**TRANSITIONAL PART 3A PROJECT
ASSESSMENT:**
***Shaolin Tourist & Residential Development
Comberton Grange South Nowra
(MP06_0135)***

Secretary's
Environmental Assessment Report
Section 75I of the
Environmental Planning and Assessment Act 1979

July 2014

Figure 9: Proposed Vegetation Removal from the Jervis Bay REP Habitat Corridor (Source: Environmental Assessment)

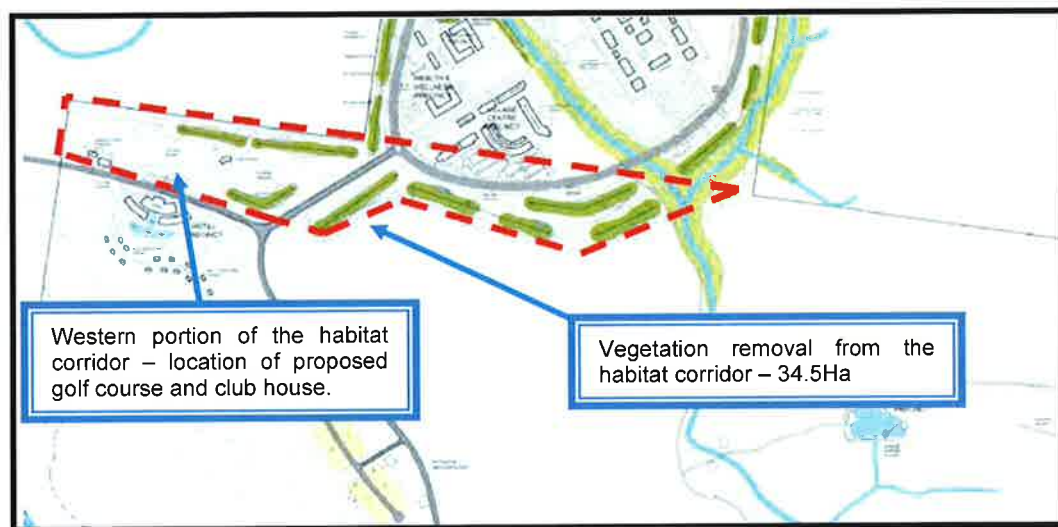
- clearing of 34.5 hectares of native vegetation in the central and western part of the site for construction of the golf course and part of the Village Centre Precinct (see **Figure 9**). This area is identified as 'habitat corridor' in the Jervis Bay REP;

Figure 13: Proposed Grade Separated Interchange (Princes Highway/Forest Road) (Source: Traffic Impact Assessment prepared by Lyle Marshall & Associates P/L, dated March 2012)

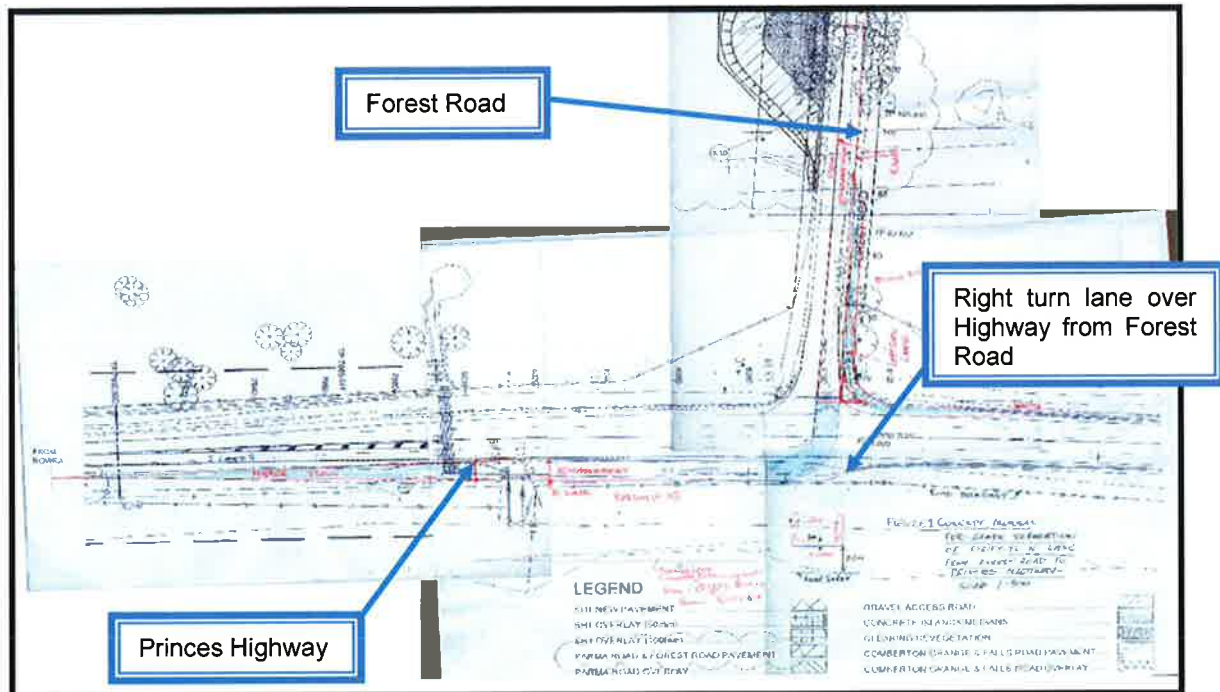
The RMS objected to the proposed traffic signals at the intersections of the Princes Highway and Forest Road and advised that it will not provide the necessary approvals required under Section 87 and Section 138 of the *Roads Act 1993*. The RMS stated that this intersection is within a 100km/hr speed zone where traffic signals are not permitted and reducing the existing 100km/hr speed zone at this location to allow for the signals for an isolated development would not be supported.

The RMS has maintained that a grade separated interchange is required for the right turn from Forest Road onto the Princes Highway at this intersection to cater for the significant increase in traffic volumes through this junction as a result of the proposed development. This treatment is required to maximise road safety and traffic level of service through the intersection.

Stage 2 of the project should not proceed without the grade separated interchange given the likely significant safety impacts that would result at the Princes Highway/Forest Road intersection. The commitment to construct the grade separated interchange satisfies these concerns and therefore forms part of the recommended modifications/terms of approval as well as requirements for future applications within the Concept Plan approval. The detailed design of the interchange can occur with subsequent development applications. The traffic modelling requirements of the RMS have also been considered and are addressed in the recommended Concept Plan approval. The construction of the grade separated interchange will be subject to a separate application and environmental assessment under Part 4 or 5 of the EP&A Act (where relevant).

- demonstrate that the existing intersection can accommodate the traffic associated with Stage 1 and to include recommended further upgrade works if required for Stage 1;
- demonstrate that the proposed interchange design can accommodate traffic associated with the ultimate project; and
- include a scaled conceptual plan of the proposed interchange and demonstrate it can be constructed in accordance with the Austroads Guide to Road Design.

Figure 15: Proposed Zoning Regime by the Proponent
(Source: Response to Submissions, Conybeare Morrison, December 2013)

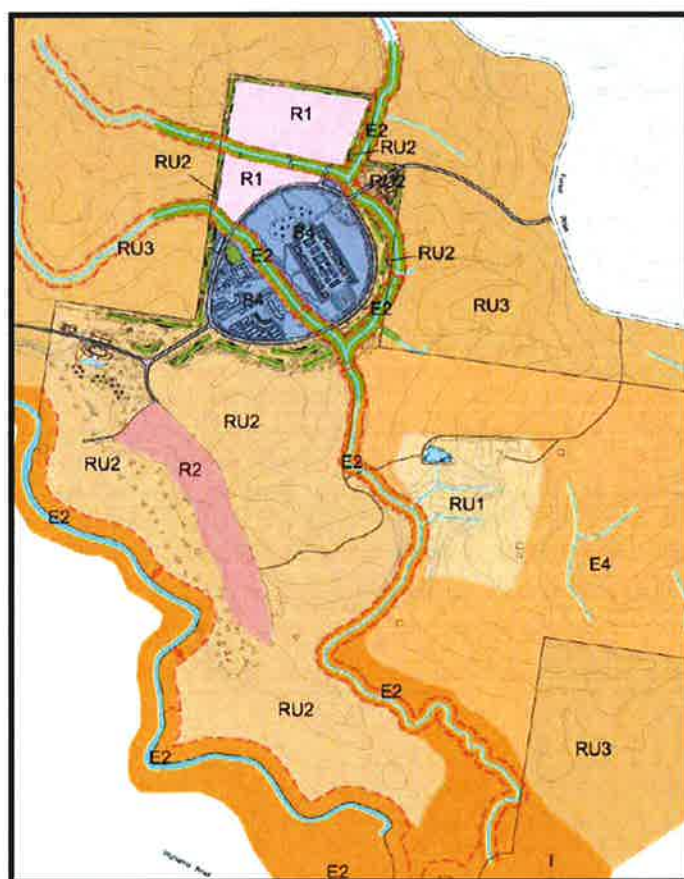
These proposed zones are illustrated in **Figure 15**. This proposed rezoning regime is significantly different to the zoning under the Shoalhaven LEP 2014. In general, the zoning regime proposed by the Proponent is not supported by the department, as outlined below.

It is therefore considered that the Proponent's proposed zoning of portions of the site to R1, R2 and B4 is inconsistent with the Panel's recommendations, the Regional Strategy and the key planning issues identified by the Panel in its assessment of future development on the site.

Overall, the department considers that the proponent's proposed zoning regime is not consistent with either the Shoalhaven LEP 2014 or the Panel's key recommendations (see Table 3). This view was supported by Shoalhaven Council and a number of agencies. As such, the Department does not support the proposed zoning changes and has recommended that a modification to the Concept Plan is imposed which does not approve this aspect of the Concept Plan.

Figure 16 Visual Sensitivity Analysis (Source: Visual Impact Assessment, Conybeare Morrison dated October 2012)

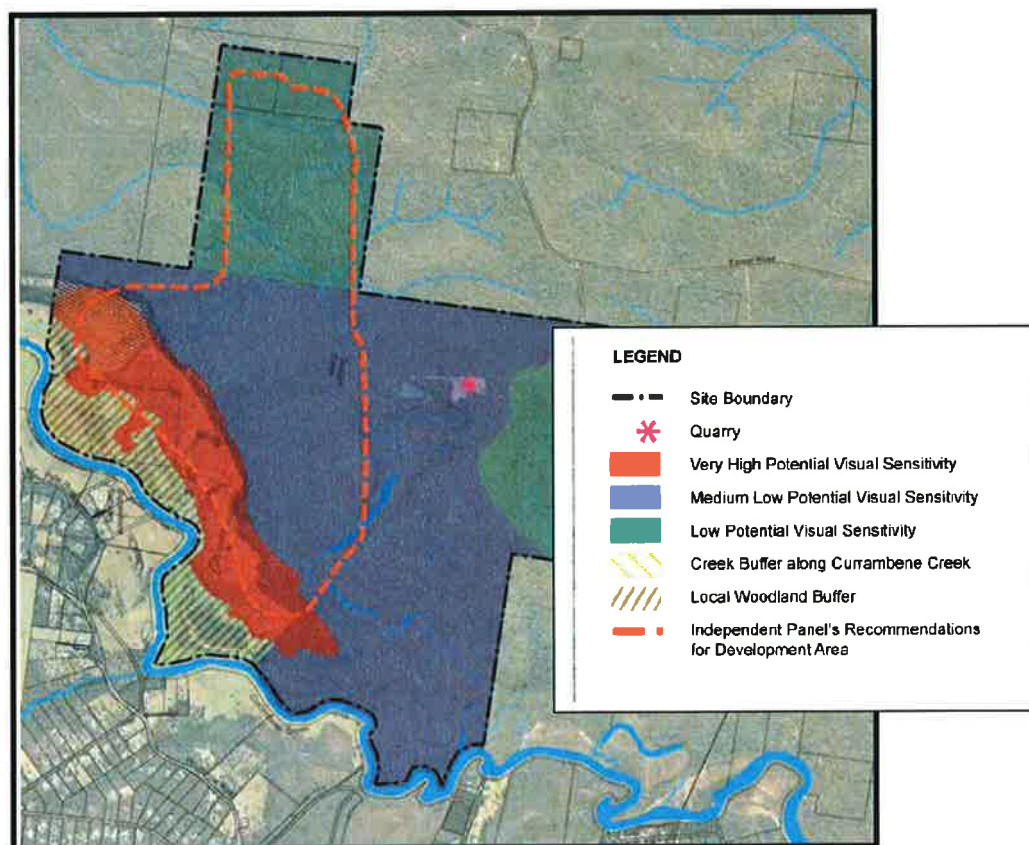
In summary, the visual report concluded that the northern portion of the site where the majority of the development is proposed, is assessed as having a low visual impact (green area on Figure 16), due to the topography of this area and the extensive vegetation within the western forest/habitat corridor which is to be retained in the central portion of the site. The western forest in the central portion of the site is considered to have a medium to low visual sensitivity due to the vegetation retained in this area and the minimal development proposed (purple shaded area on Figure 16). The farmland sub-precinct is assessed as having a very high visual sensitivity due to the lack of any significant topographical features, the sparseness of the existing vegetation and the generally exposed nature of this setting (orange shaded area).
